PARKSIDE MONTESSORI MPR AND SITE PROJECT

ADDENDUM NO. 2

Date: November 6, 2023

Project: Parkside Montessori MPR & Site Project
DSA #: 01-120306 41-26

14. SHEET 'G0.2 PROJECT DATA SHEET'

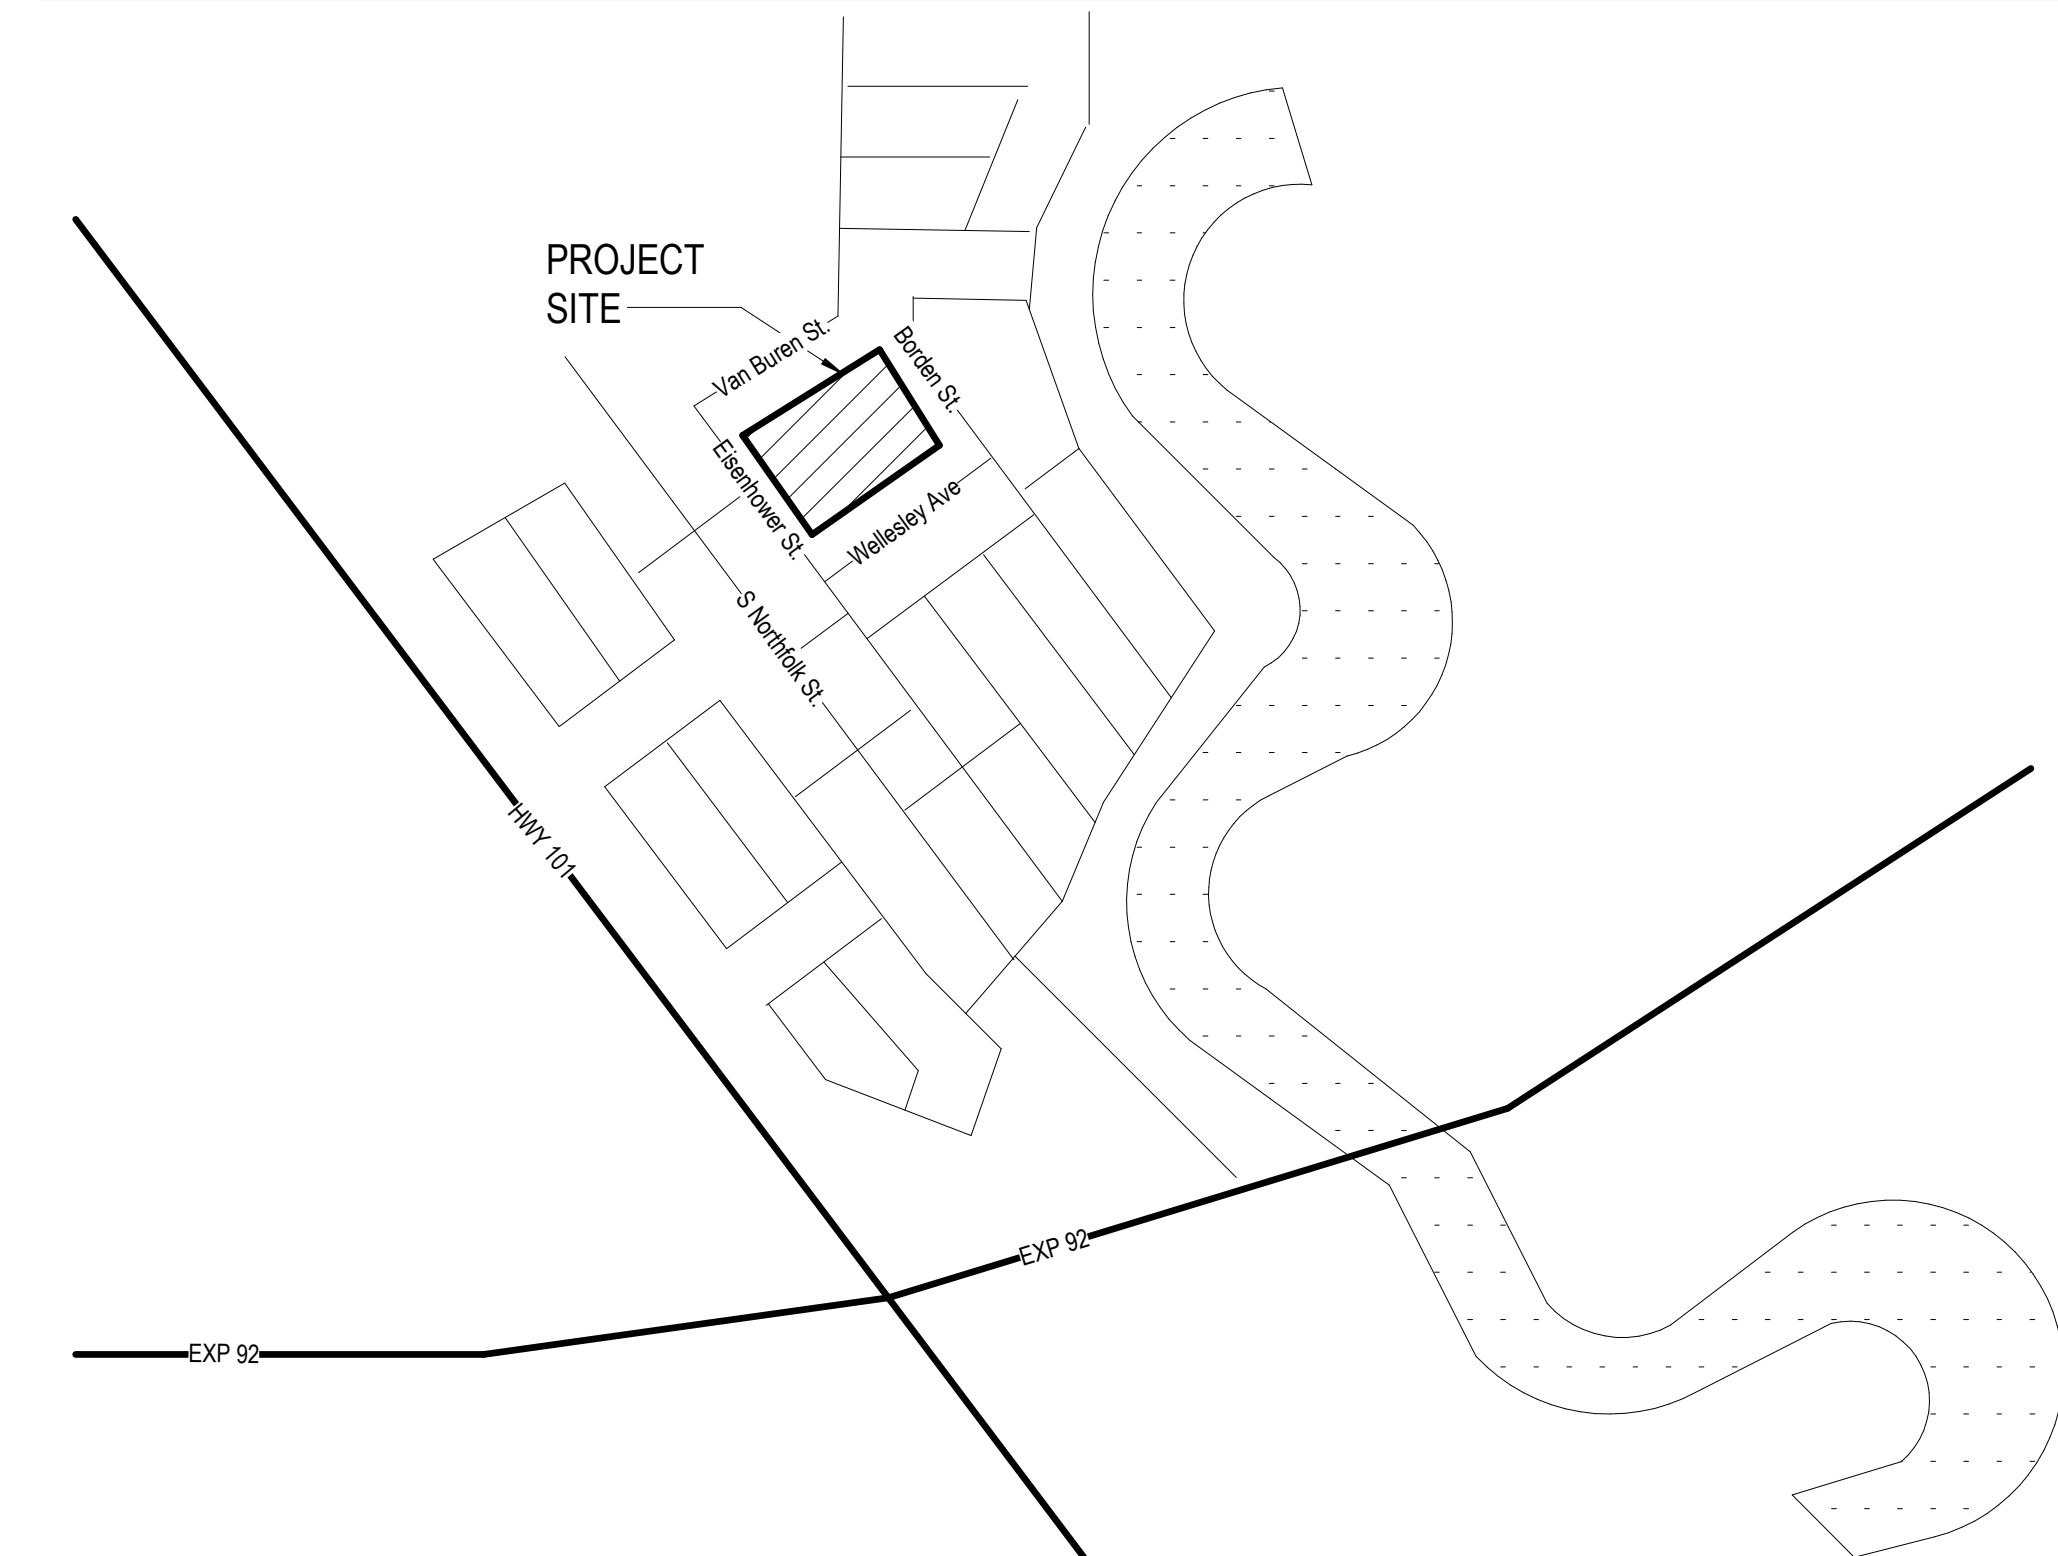
- A. Revised list of ADD ALTERNATE.
- B. There are no bid alternates in this project. All scope shall be part of base bid.

3. **SHEET ‘C2.3 SITE IMPROVEMENT PLAN’**

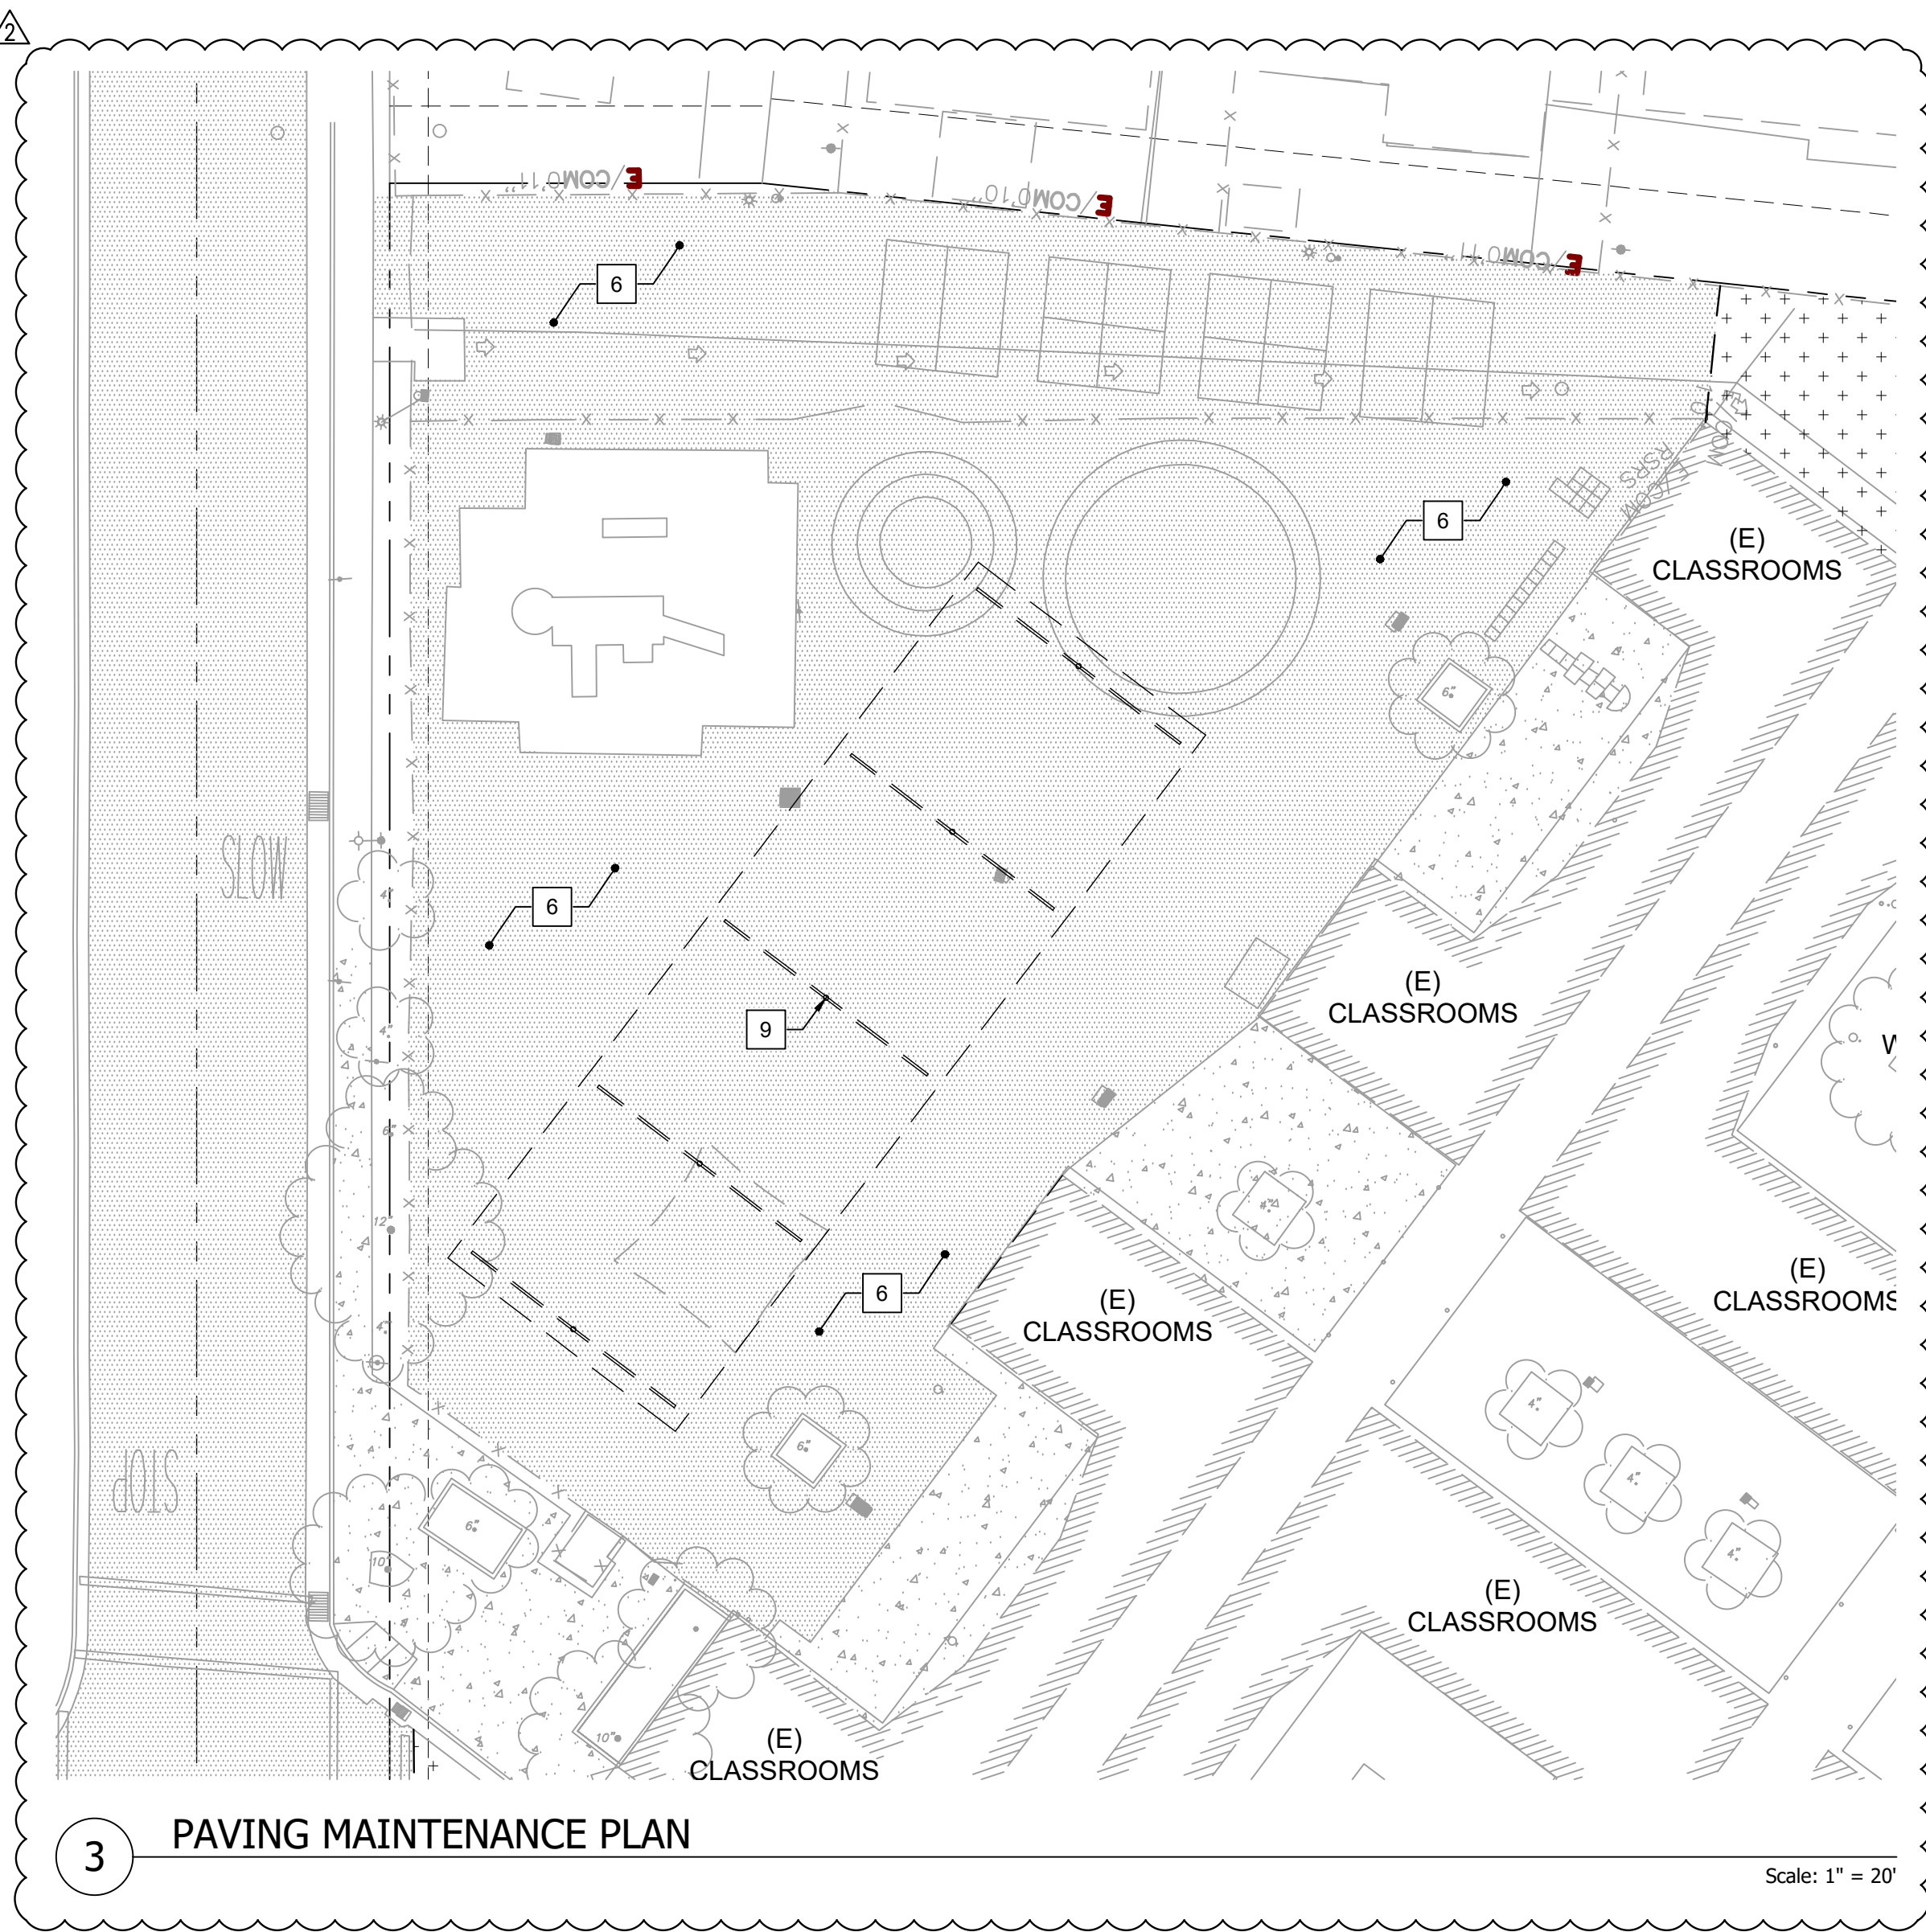
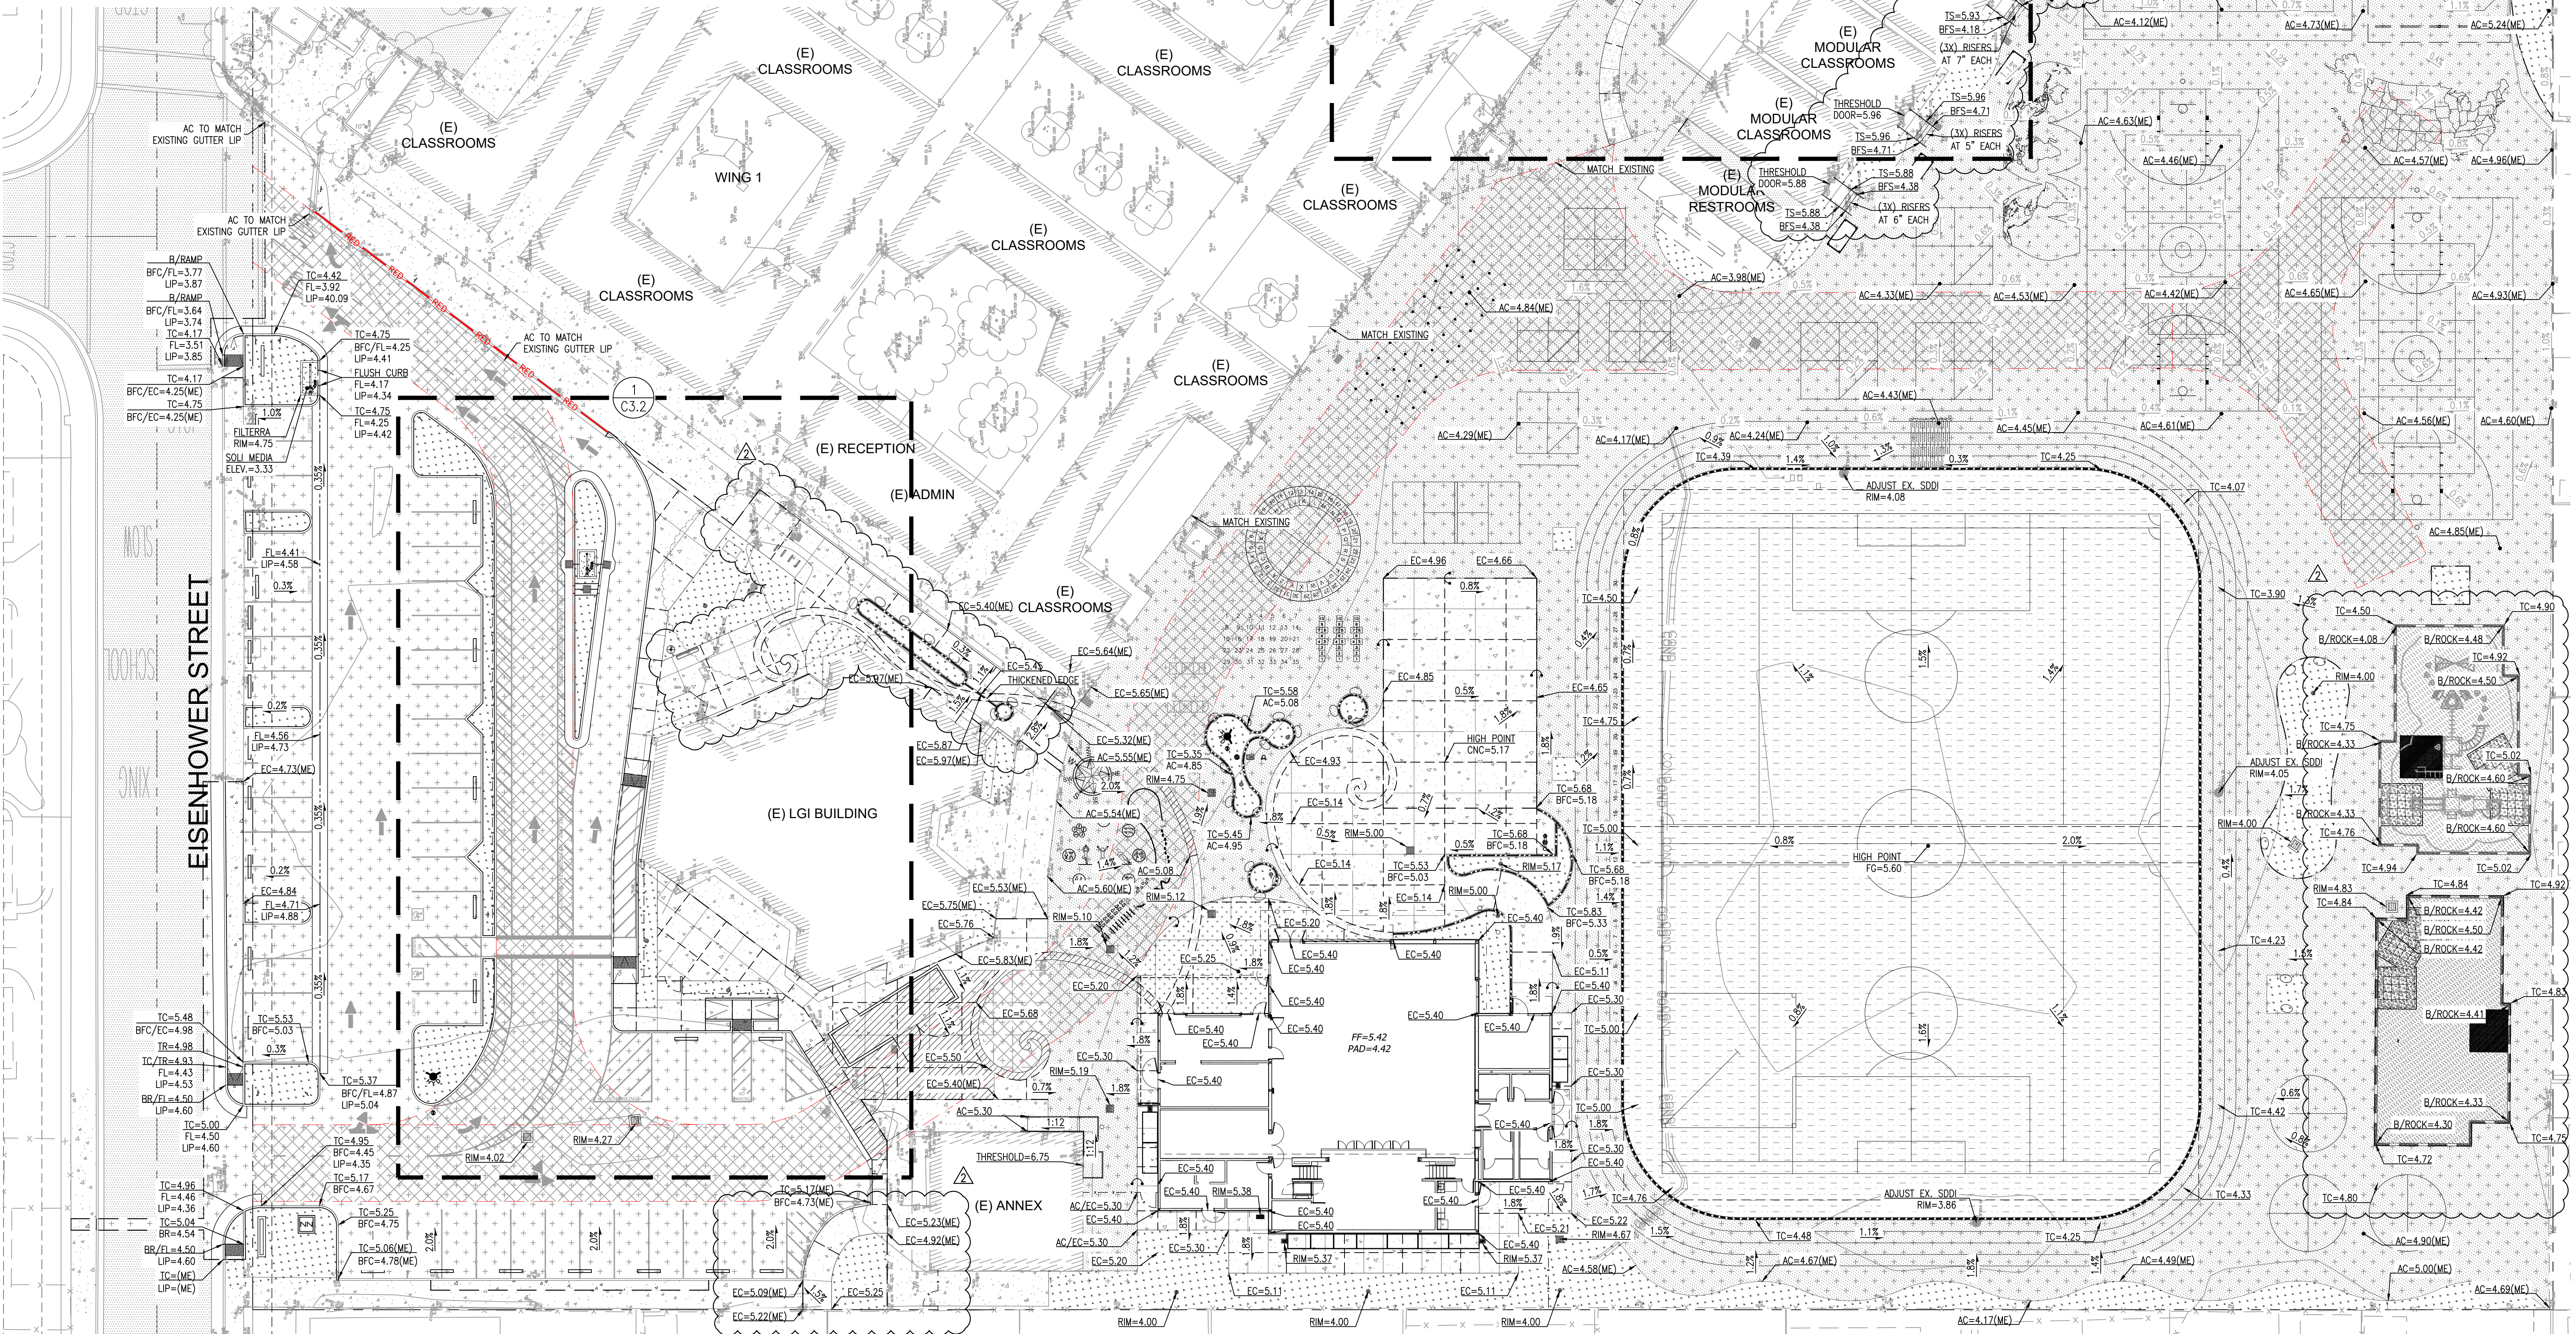
A. Added notes and Detail 3 to show added AC paving maintenance scope.
